Reference: 24.011r01v02

Re: **280 Condamine Street, Manly Vale – Residential Aged Care Facility (PLM2023/0094)
Traffic Engineering Services
Response to Request for Information (RFI)**

Architectural Plans

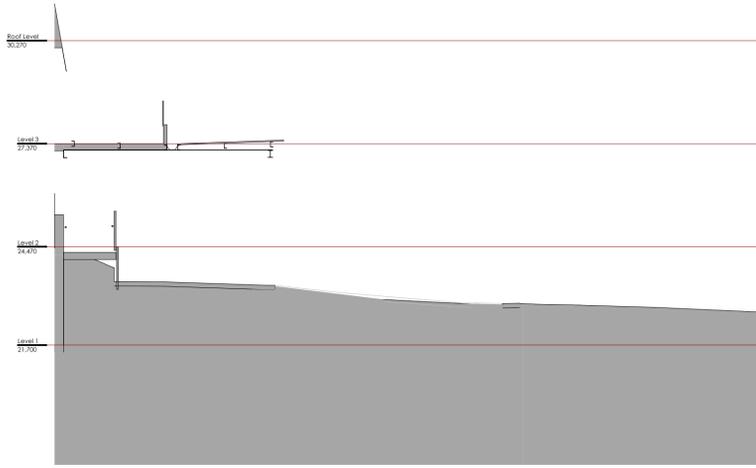
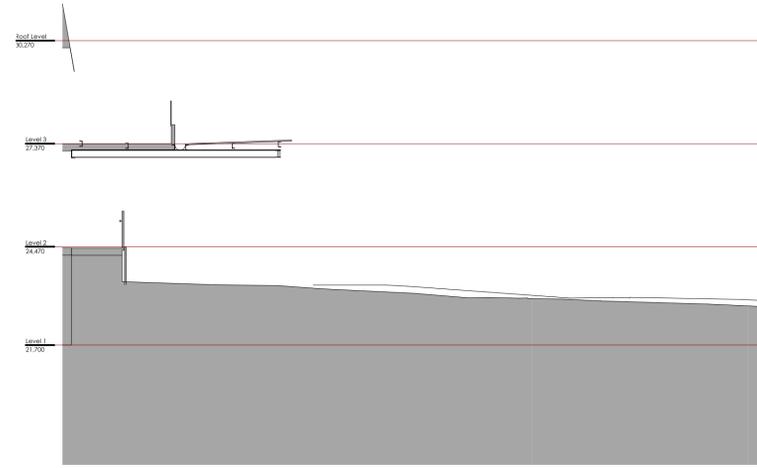
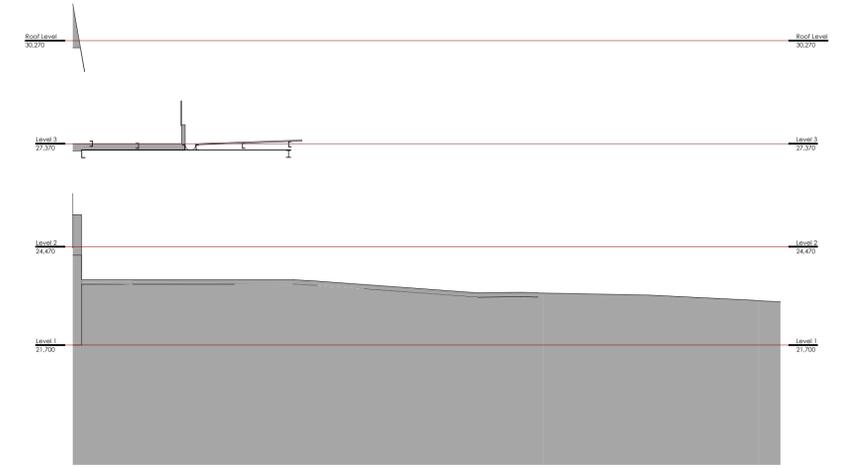
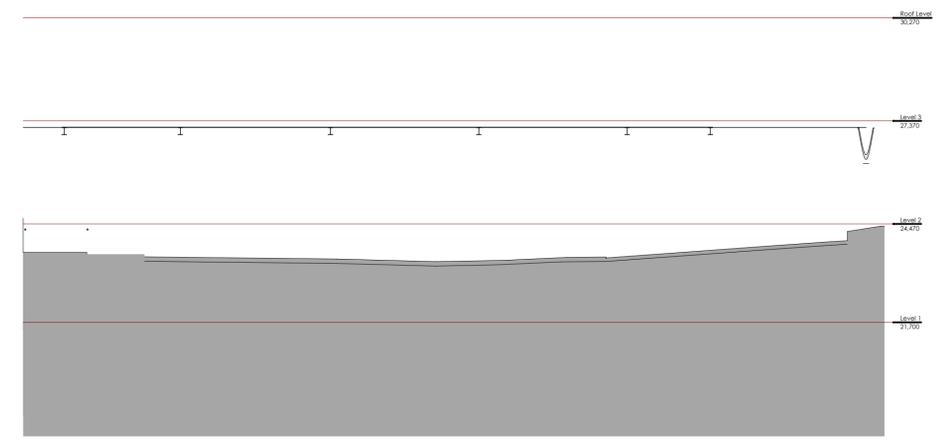
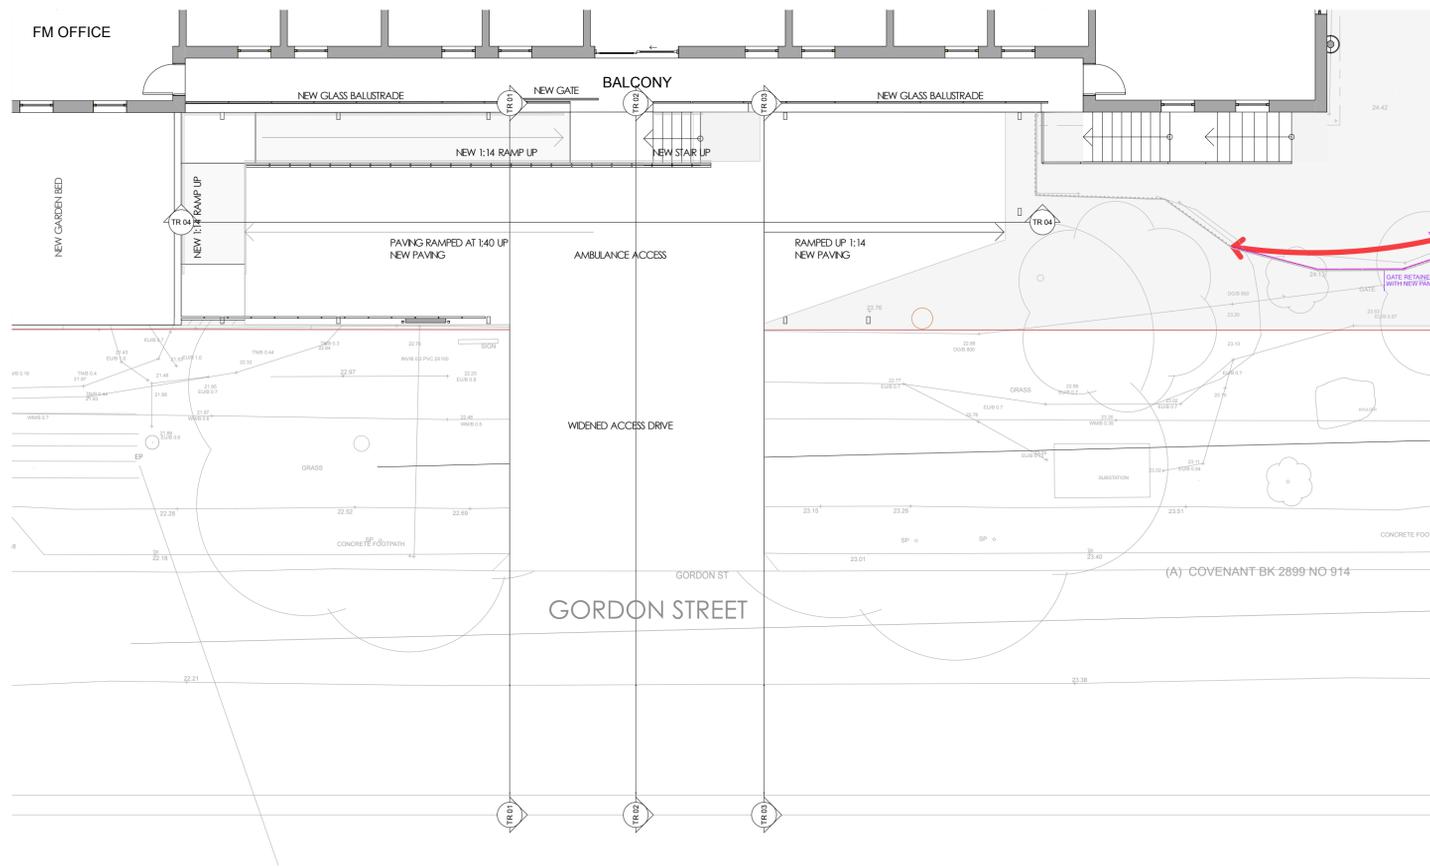
3. *A long section and cross sections for the proposed driveway with chainage, grades and existing & proposed levels are to be included in the submission.*

Reference should be made to the long sections for the proposed driveway provided in **Attachment 2**.

Drawing Title
 Swept Path Analysis
 6.025m 2-WD Mercedes Benz Sprinter Ambulance
 Inbound Movement from Gordon Street

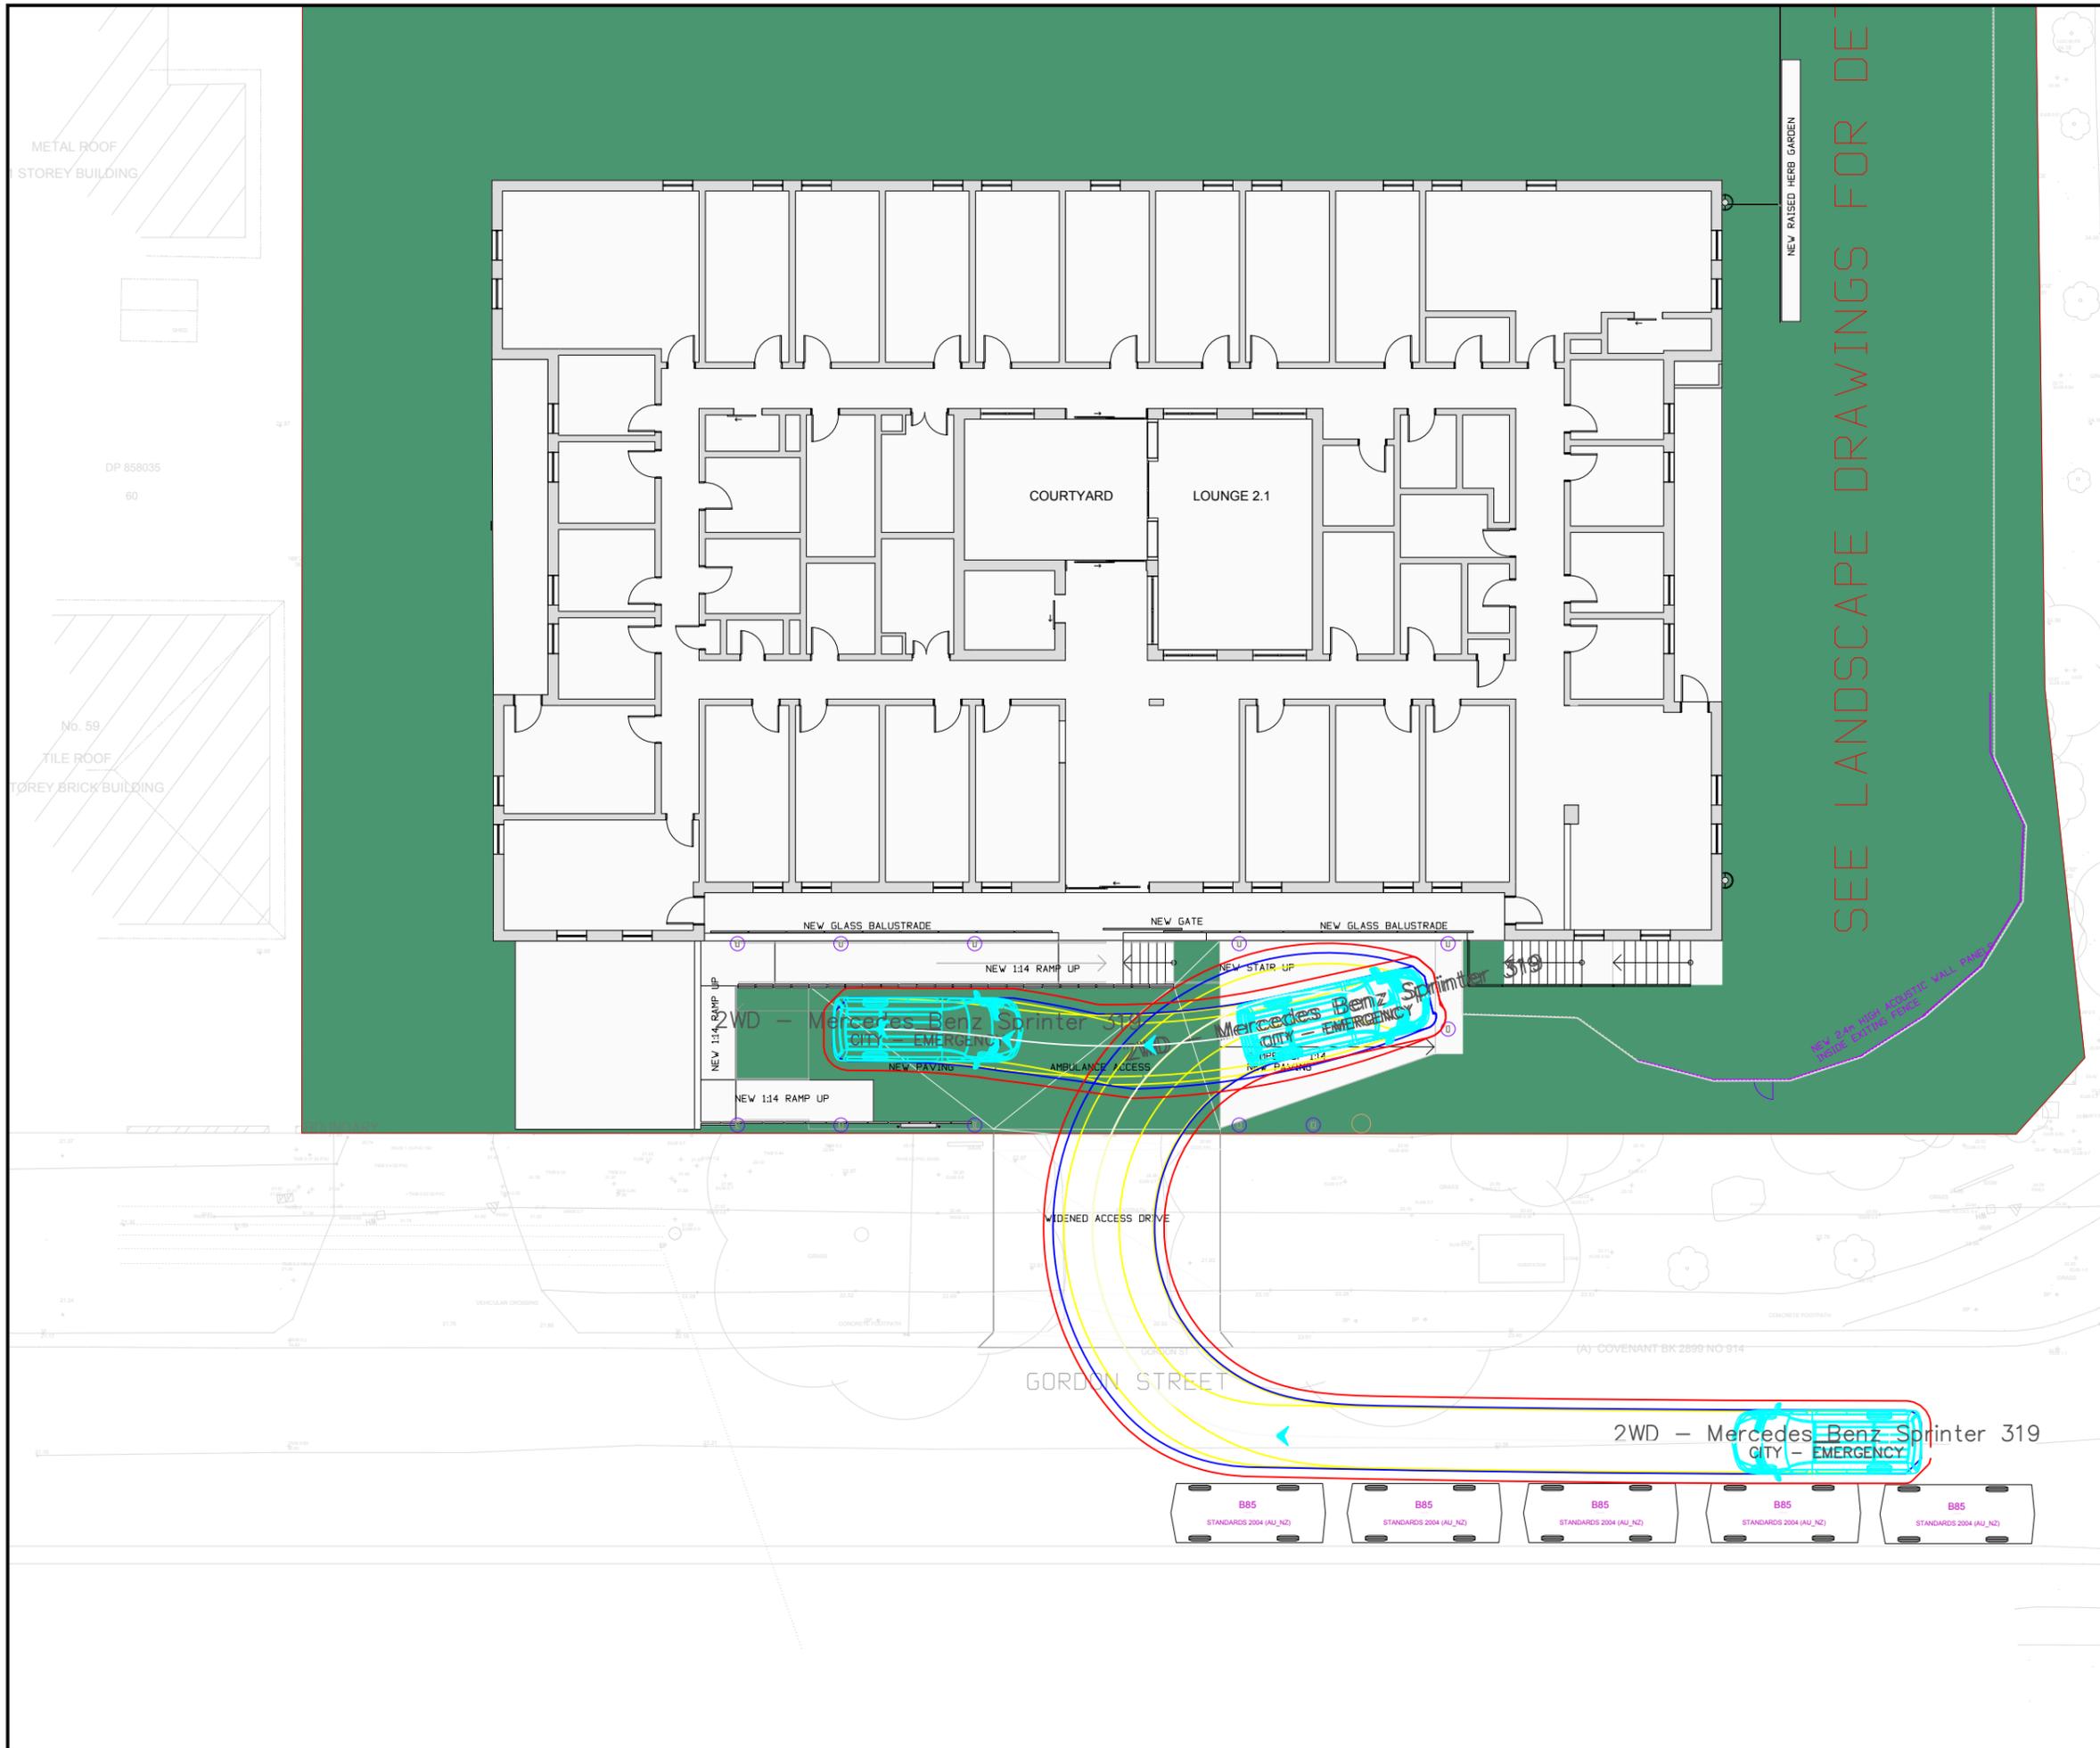
4. *Swept paths using ambulance should be provided, driveway design should allow for forward entry/exit.*

Reference should be made to the swept path analysis provided in **Attachment 3** showing that an ambulance can enter and exit the subject development in a forward direction, in accordance with AS2890.1 in accordance with Council requirements.

Drawing Title
 Vertical Clearance Test
 Long Section - TR01
 6.4m SRV - Ambulance
 Above: Inbound
 Below: Outbound

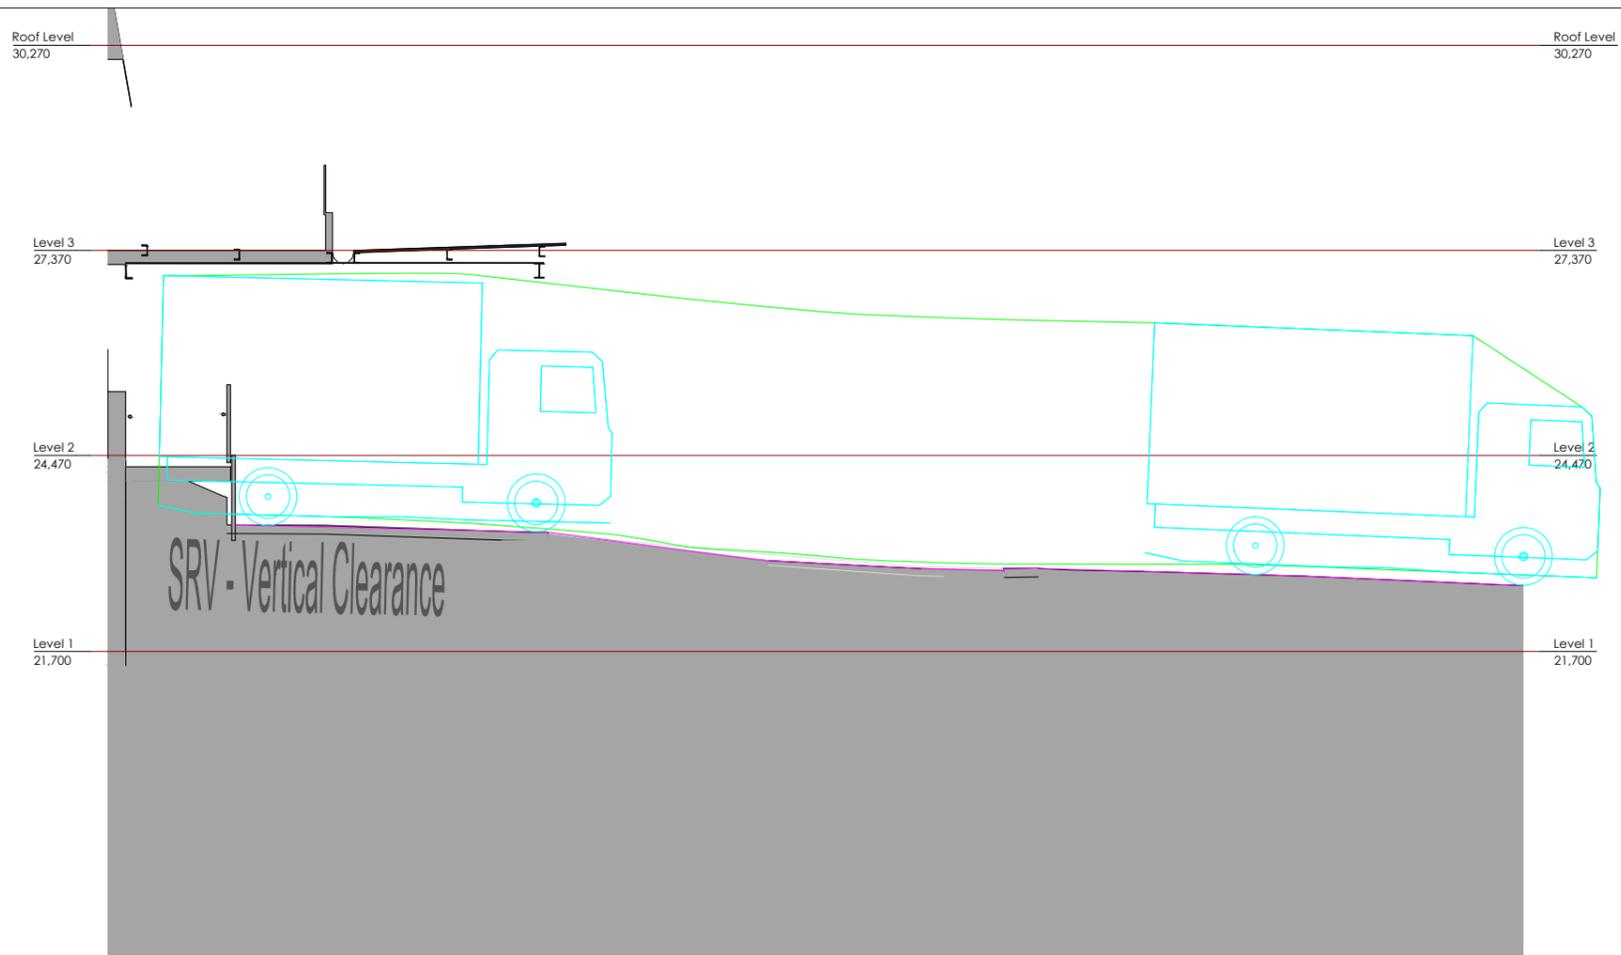
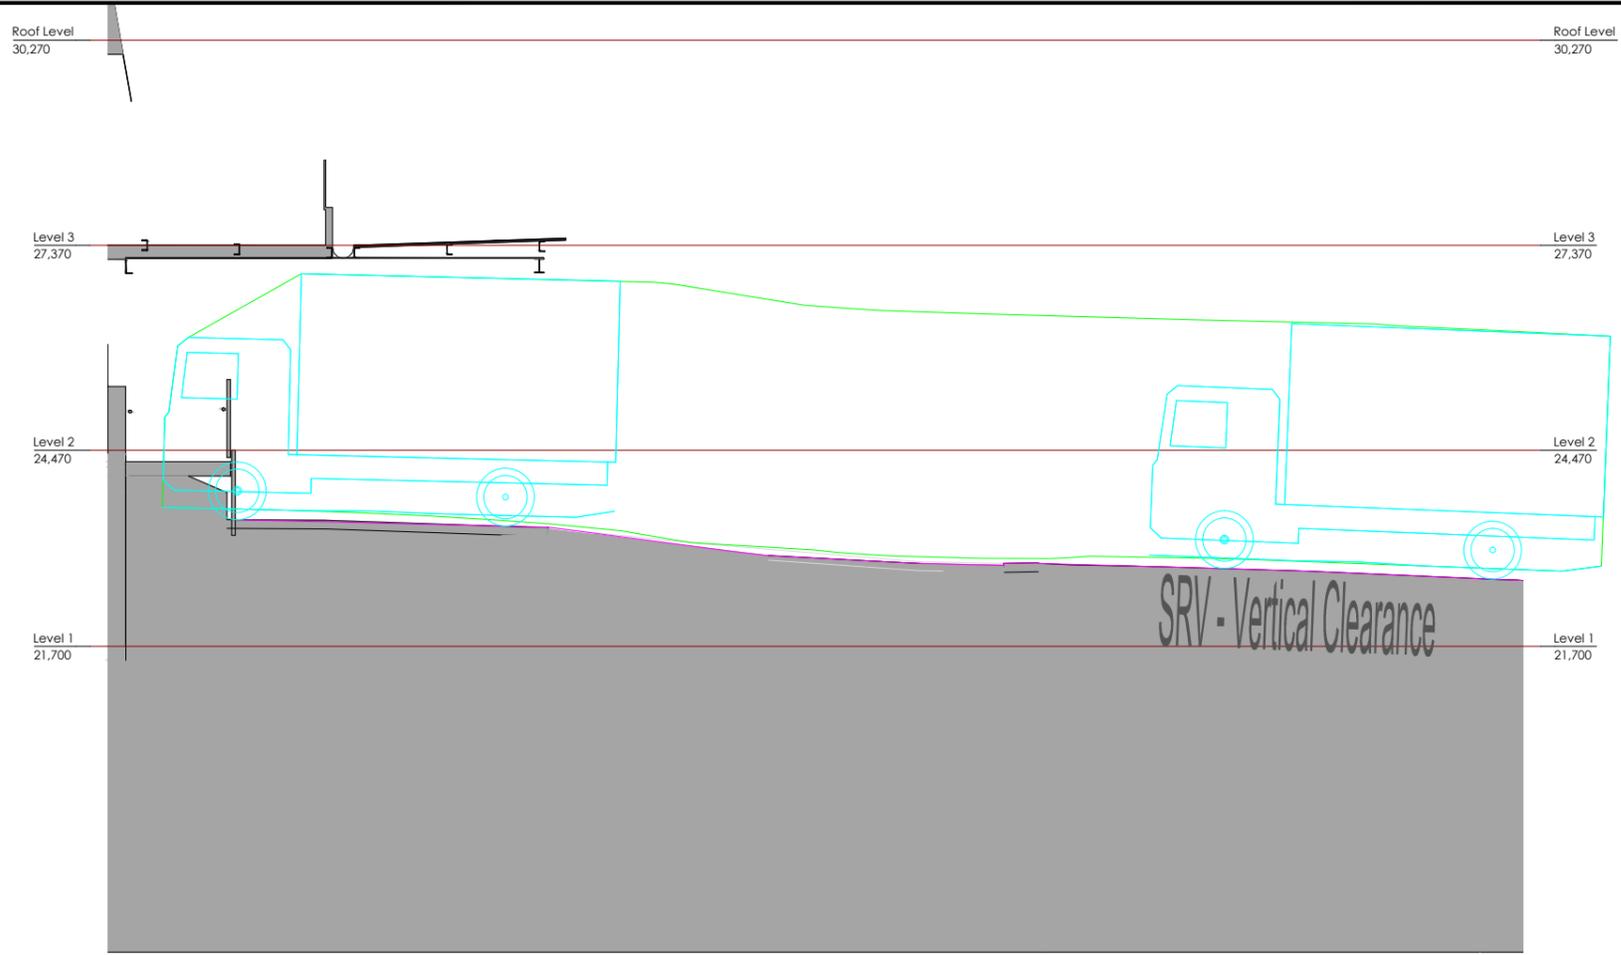
The internal driveway access grades, driveway crossing widths must be in accordance with AS2890.1.

The internal driveway is provided in accordance with AS2890.1. Reference should be made to the swept path analysis provided in **Attachment 3** and to the Vertical Clearance Test provided in **Attachment 4** showing the satisfactory operation of the proposed access driveway suitable to accommodate a typical ambulance (6.4m SRV).
